ZEE Systems, Inc.

SERVICE LETTER 43-000

B. REASON: This Service Letter gives recommended procedure for the addition of an optional hour meter to track system operating time for the purpose of accurate maintenance scheduling (TBO).

FIG. 1

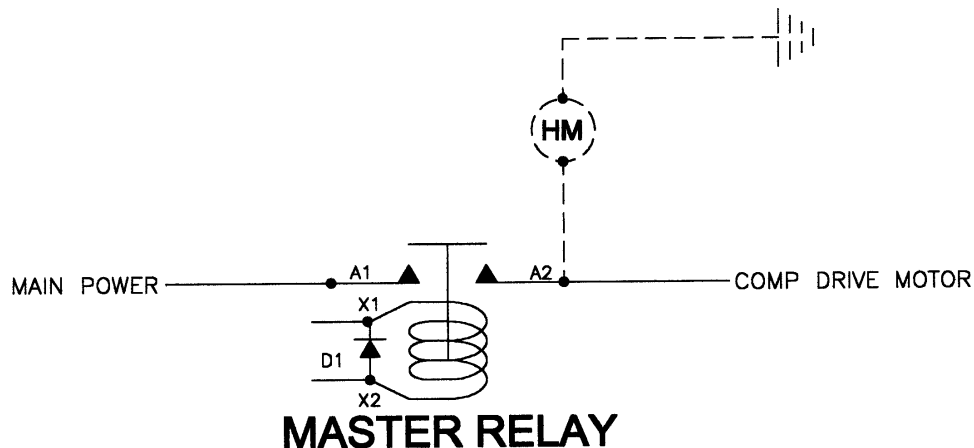
E. CHANGE: Below FIG. 1 is a recommend circuit for the addition of an hour meter. This service Letter does not provide any mounting or structural modifications for the installation of the hour meter.

1. Use wire that conforms to M22759/16-(size)-9.
2. Use Terminal Rings that conform to MS25036 specifications.
3. Identify new wire(s) and mark new wire(s) in accordance with AC43.13-1B.
4. Secure wire in accordance with AC 43.13-1B.
5. Make all required log book entries.
